Access Compliance Report

Public Rights-of-Way

(Curb Ramps)

Intersection ID: 22297	Main Street: HIGHVIEW_RD	Cross Street: RIESMAN_LN	Location: SW
ADA ID: 51BA3C27E4E1	Ramp Type: PerpDiag	Initial Pass/Fail: Pass	Overall Compliance: No
Severity Score: 7.75			
Codes/Mitigation Info/Possible Solution		Field Measurements/Component Compliance

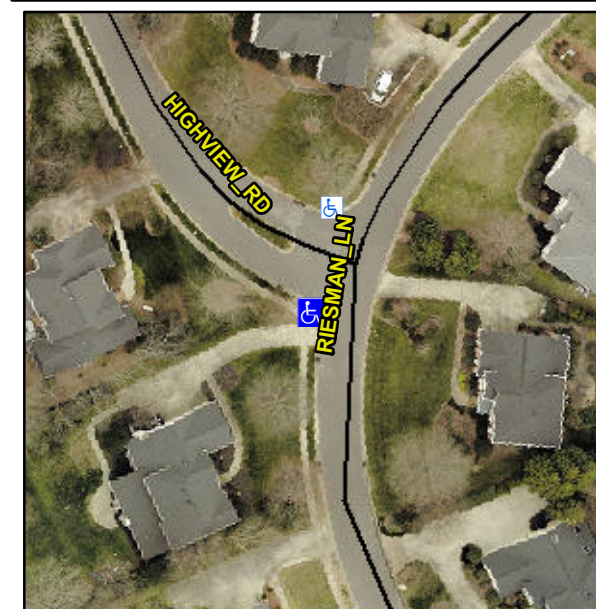
Not Found, R304.5.3, R304.2.2-Perp, R304.3.2-Para, R305.1.4, R305.2, R304.5.4

Compliance	Description	Data	Compliance	Description	Data
N/A	Ramp Length (in)	49.0	Yes	Ramp Slope (%)	6.5
Yes	Ramp Width (in)	100.0	No	Ramp XSlope (%)	4.7
N/A	Flare Type LT	None	N/A	Flare Type RT	N/A
N/A	Flare Slope LT (%)	N/A	N/A	Flare Slope RT (%)	N/A
N/A	Flare Traversable LT?	N/A	N/A	Flare Traversable RT?	N/A
Yes	Landing Length (in)	49.5	Yes	DWS Provided?	Yes
Yes	Landing Width (in)	100.0	Yes	DWS Contrast?	Yes
No	Landing Slope (%)	3.0	Yes	DWS Length (in)	24.0
No	Landing X Slope (%)	6.5	No	DWS Full Width?	No
N/A	Landing Curb? (Y/N)	No	No	DWS Offset (in)	4.0
N/A	Shared Landing?	No			
Yes	Gutter Ponding?	No	No	Gutter Slope (%)	12.4
Yes	Gutter Lip Ht (in)	0.0	No	Gutter X Slope (%)	3.2
N/A	Painted X Walk1?	No	N/A	Painted X Walk2?	No
	X Walk 1 Direction	To E		X Walk 2 Direction	To N
N/A	X Walk 1 Width (in)	N/A	N/A	X Walk 2 Width (in)	N/A
	X Walk 1 Slope (%)	2.2		X Walk 2 Slope (%)	7.3
	X Walk 1 X Slope (%)	4.1		X Walk 2 X Slope (%)	0.5

Remove & Replace Curb Ramp With Two New Directional Ramps or Equivalent. Remove & Replace Gutter.
